Subject: CAR14-00010/PUD14-00003 – Kensington Apartments at North Pointe
7410 W State Street

Project/File: **Kensington Apartments at North Pointe/CAR14-00010/PUD14-00003**
 The applicant is requesting rezone and planned unit development approval to rezone 26.5 acres of C-4D, L-OD, and R-2D to C-4D to allow for the development of 312- multi-family residential units. The site is located at 7410 W. State Street in Boise, Idaho.

Commission Hearing: *Regular Agenda*
 June 25, 2014

**The Kensington Apartments at North Pointe - Option E
(WITH EXISTING EASEMENT)**

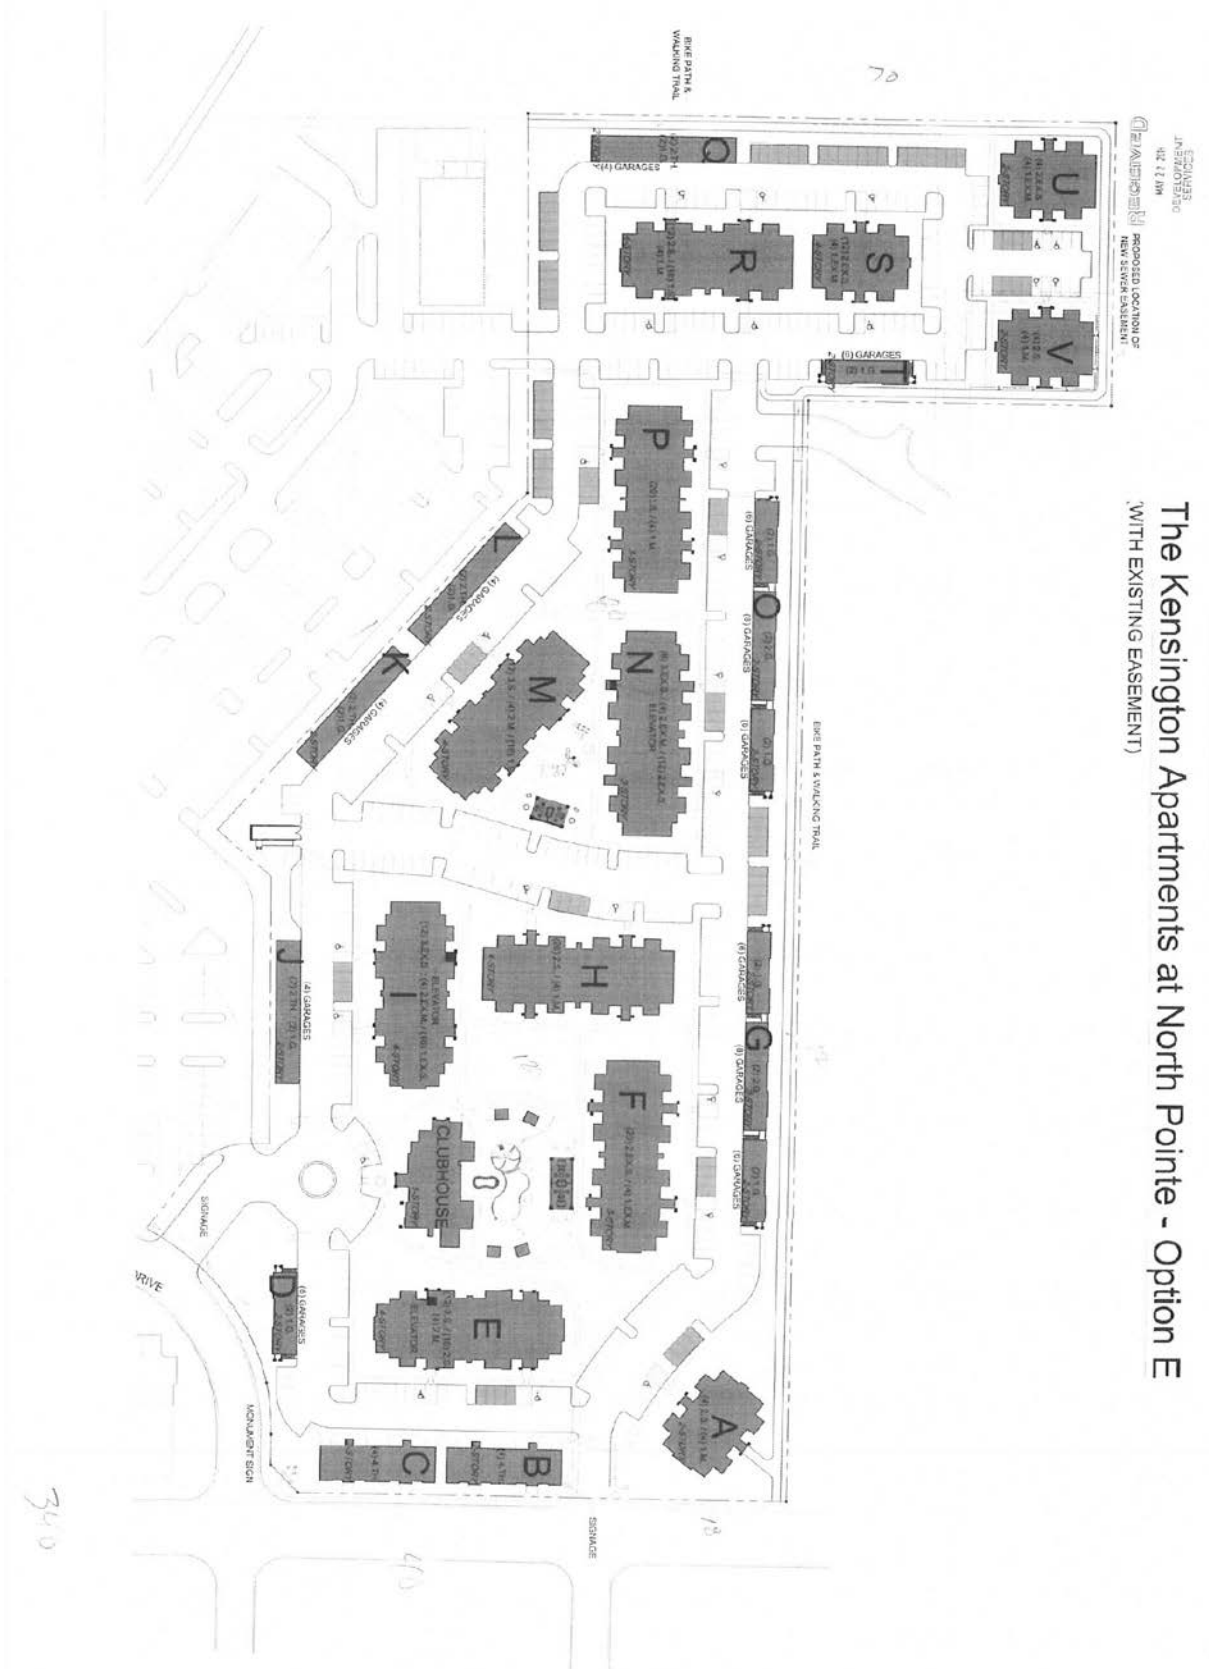
- c. **Applicant's Proposal:** The applicant is proposing to reduce the existing driveway to a 30-foot wide driveway approximately 325-feet north of the Gary Lane/ Saxton Dr. intersection and 330-feet south of Baron Lane and in alignment with Bluebird Drive (measured centerline to centerline).
- d. **Staff Comments/Recommendations:** The applicant's proposal does not meet District Driveway Location policy because it does not meet the minimum distance for a full movement driveway. However, staff recommends a modification of policy to allow the driveway to be located as proposed, due to the fact that there is a center turn lane on Gary Lane, the proposed driveway is in alignment with Bluebird Drive directly east of the site, and the entrance was approved with the previous development application.

- c. **Applicant’s Proposal:** The applicant is proposing to close the existing driveway located approximately 195-feet west of Gary Lane with curb, gutter, and sidewalk and construct a 40-foot wide driveway approximately 250-feet west of Gary Lane and 75-feet east of the nearest existing driveway (measured centerline to centerline) onto Saxton Street from the site.

- d. **Staff Comments/Recommendations:** The applicant's proposal does not meet District Driveway Location and Success Driveway policies because it does not meet the minimum distance required for a full movement driveway. However, staff recommends a modification of policy to allow the driveway to be located as proposed, due to the fact that the driveway is located outside of the area of influence of the intersection, there is a center turn lane on Saxton Drive, and Saxton Drive was originally built as a local/commercial and the driveways were approved with that application.

3. Construct a 30-foot wide driveway on Gary Lane located in alignment with Bluebird Drive. This is approved as a temporary full access. Pave the driveway its full width and at least 30-feet into the site beyond the edge of pavement.

4. Close the existing driveway located 195-feet west of Gary Lane with curb, gutter, and sidewalk.
5. Construct a 40-foot wide driveway on Saxton Drive located approximately 250-feet west of Gary Lane. Pave the driveway its full width and at least 30-feet into the site beyond the edge of pavement.
